UNITED STATES PATENT AND TRADEMARK OFFICE

| APPLICATION NO. | FILING DATE | FIRST NAMED INVENTOR | ATTORNEY DOCKET NO. | CONFIRMATION NO. |
|-----------------|-------------|----------------------|---------------------|------------------|
| 09/971,763 | 10/09/2001 | Moo-youl Kim | P56598 | 4212 |

Office Action Summary

DETAILED ACTION

FIG. 17

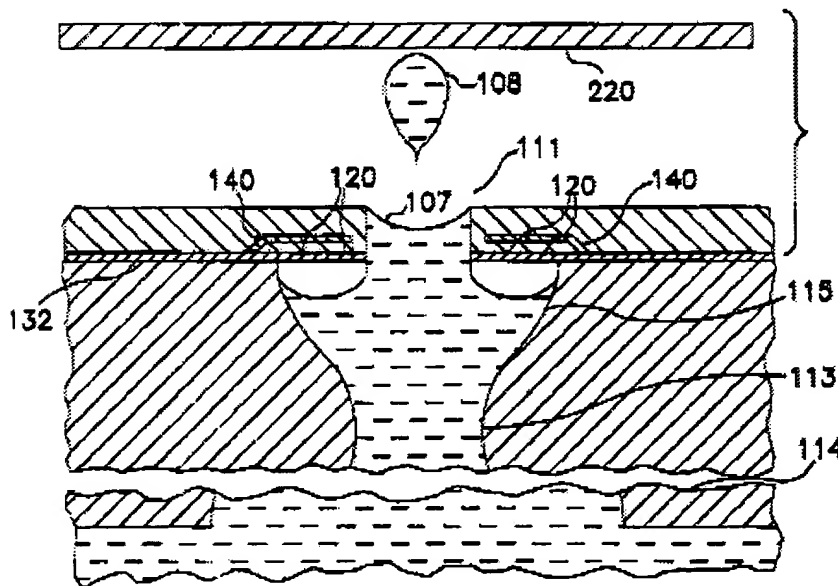
Silverbrook teaches (Fig. 17, above) an ink jet print head comprising a base plate (130), which is perforated by an hour-glass shaped structure having a hemispherical shaped top portion that is filled with ink, a nozzle plate that is mounted on the base plate and is perforated by a plurality of orifices in communication with their respective chambers, a plurality of dough-nut shaped heaters (120) disposed on the underside of the nozzle plate and surrounding each nozzle and a plurality of circular ink inlet passages (113), which supply ink from a reservoir to the hemispherical hour-glass shaped chamber. As can be seen Fig. 18 (which is a reverse structure of Fig. 17), each hemispherical chamber is connected to a funnel shaped chamber (489). Since Fig. 18 is a reverse of Fig. 17, these funnel shaped chambers would be found beneath the hemispherical chambers of Fig. 17. Silverbrook further teaches that that the chamber is disposed between the ink inlet passages and the orifices, that the ink inlet is connected to respective ones of the chambers and that the ink inlet has a diameter that is much smaller than the diameter of the chambers. Since the diameter of the inlet is much smaller than the diameter of the chamber, the inlet would have a smaller volume of ink than the chamber.

Silverbrook teaches the claimed invention with the exception of the ink inlet passages each having a plurality of grooves formed at an inner wall, the plurality of grooves extending through the base plate, the plurality of grooves being formed over an entire portion of said inner wall and the plurality of grooves extending in a direction parallel to a direction through said substrate and the grooves being formed around the entire circumference of the ink passages.
